SUBJECT: Potential Defective Overload Relay Heaters -
Advisory Pursuant to 10 CFR 21 for Controllers
Utilizing Overload Relay Heaters Catalogued
G30T9 Through G30T16

Potential Defective Overload Relay Heaters -
Advisory Pursuant to 10 CFR 21 for Controllers
Utilizing Overload Relay Heaters Catalogued
G30T Through G30T16

WIREWOUND OVERLOAD
RELAY HEATER ASS'Y.
TYPICAL T9 THRU T16

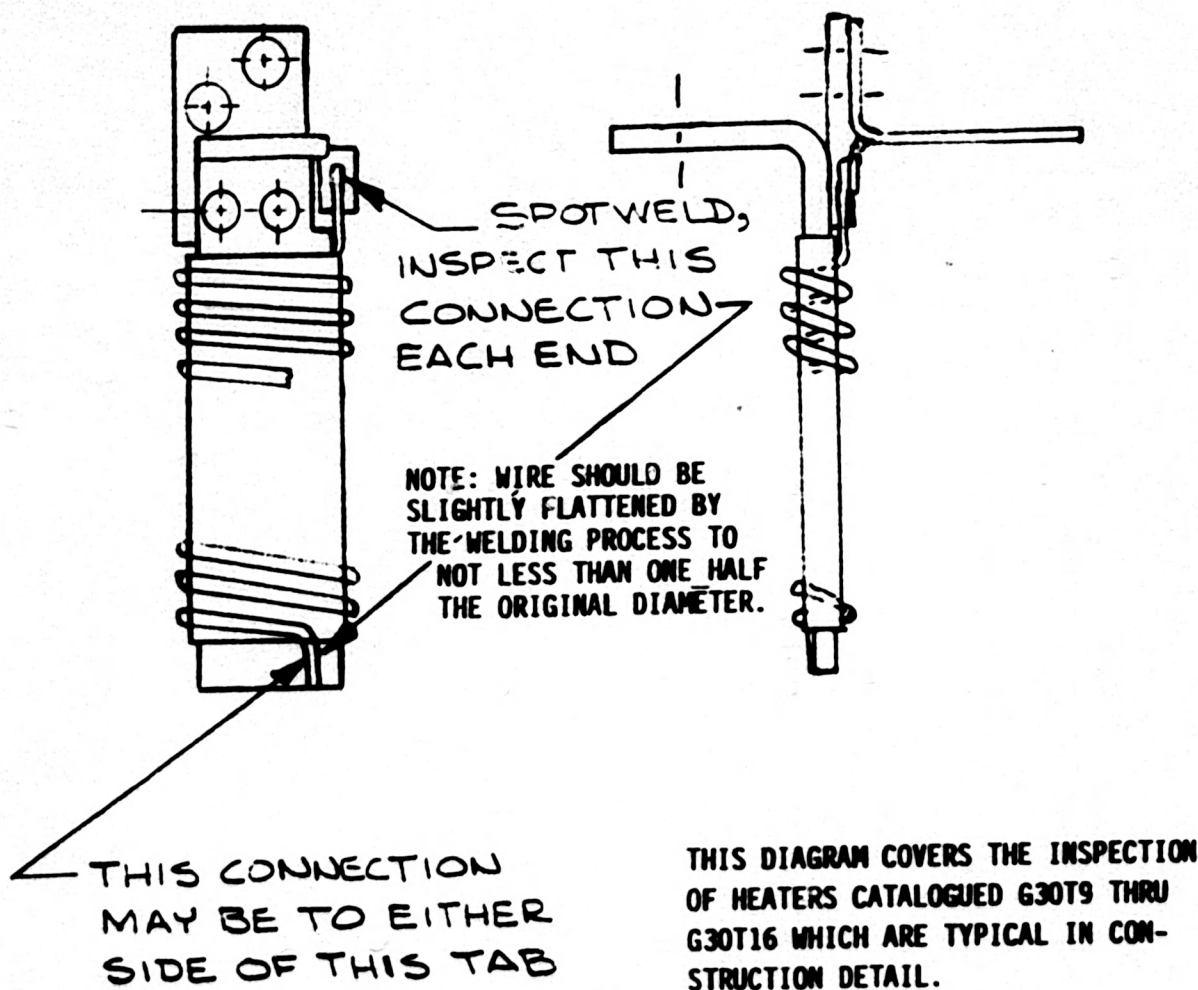
Weak resistance welded electrical connections were found in a small percentage of assemblies during an inspection of a large quantity of wire wound overload relay heaters issued from warehouse inventory. The weak welds were detected at the points of attachment of the heating element wire to the main sheet metal current carrying and terminal support components (Diagram E066, attached). Visual inspection can be used to identify heaters which have suspect welded connections.

Verification of inventory of listed catalog numbers can be made by visual inspection. A properly welded wire will have been deformed by heat and pressure to approximately one-half the original wire diameter. Inspection should be made to visually verify flattened wire at the welds.

No other corrective action is required.
